Modification of Development Consent

For the following: Moolarben Coal Project Stage 2

Modification: Mod 5 - CWO Transmission Line

Figure 2.2: Interaction of General Project Arrangement with CWO REZ Transmission Project

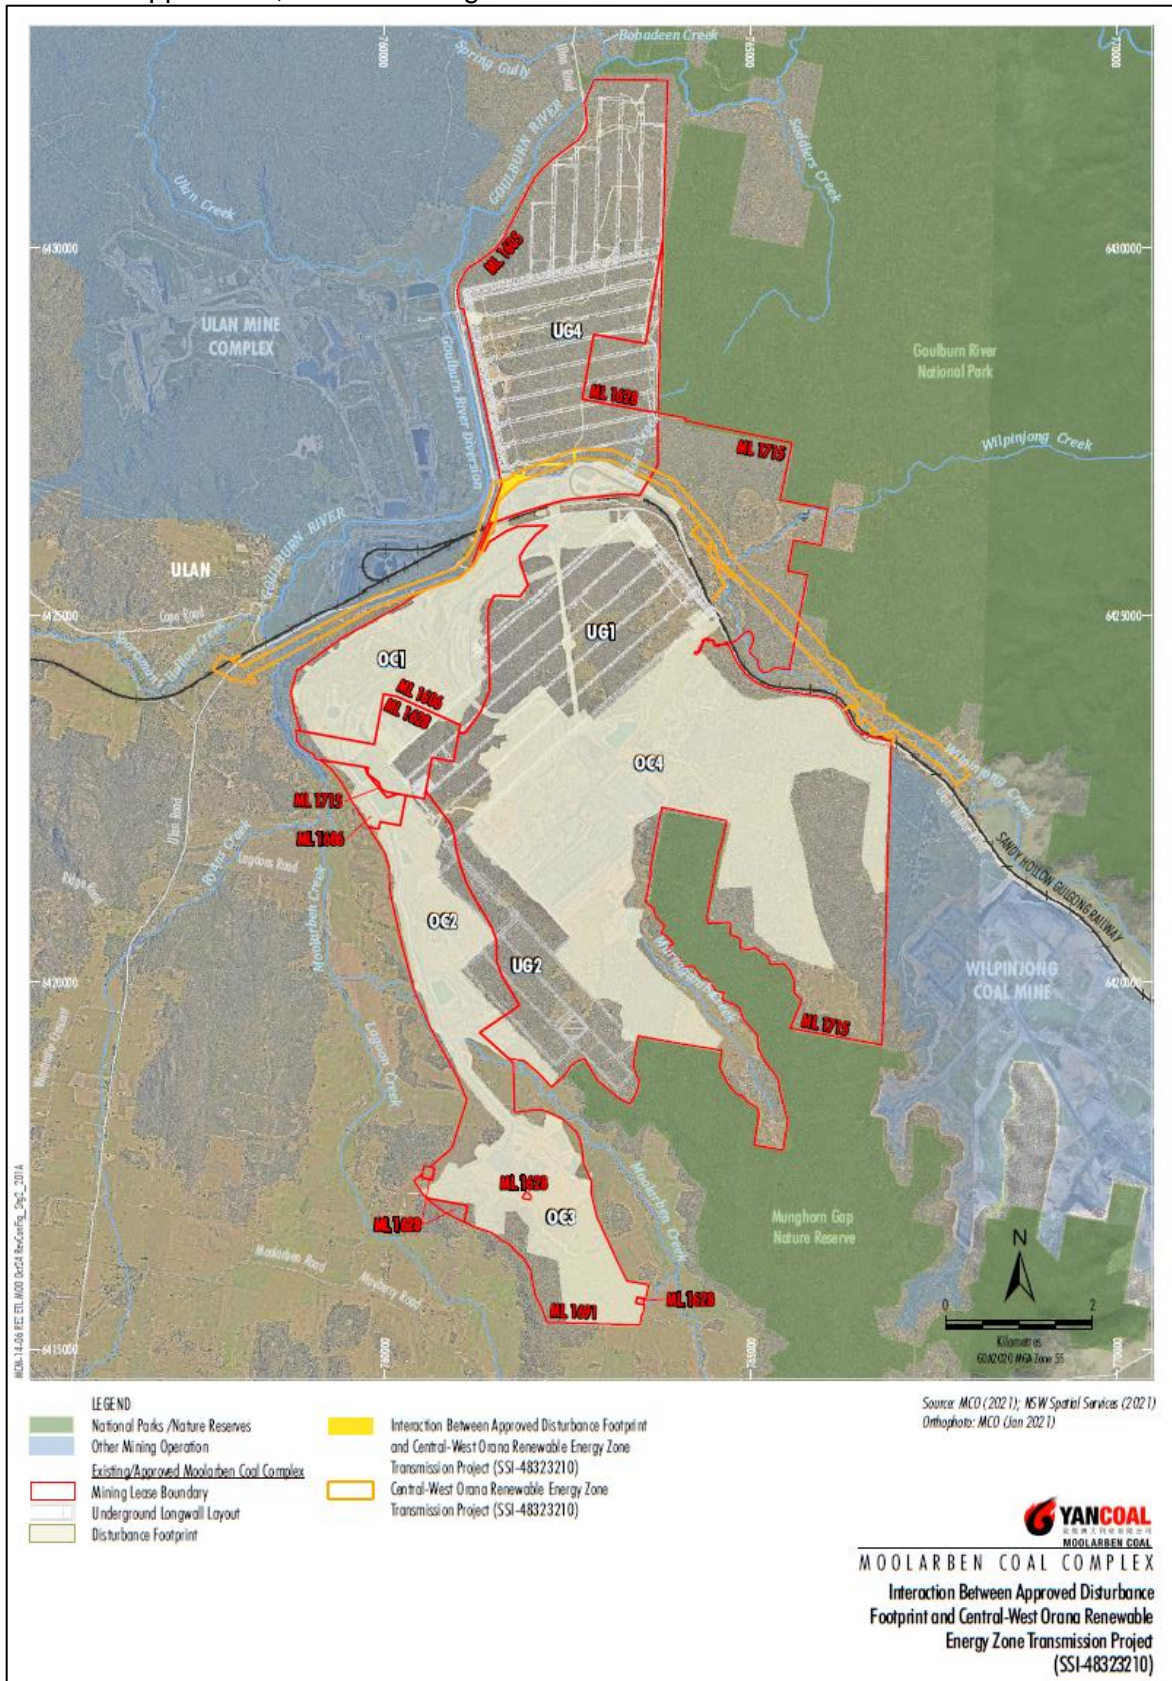
10. In Appendix 2, insert after Figure 2.1:
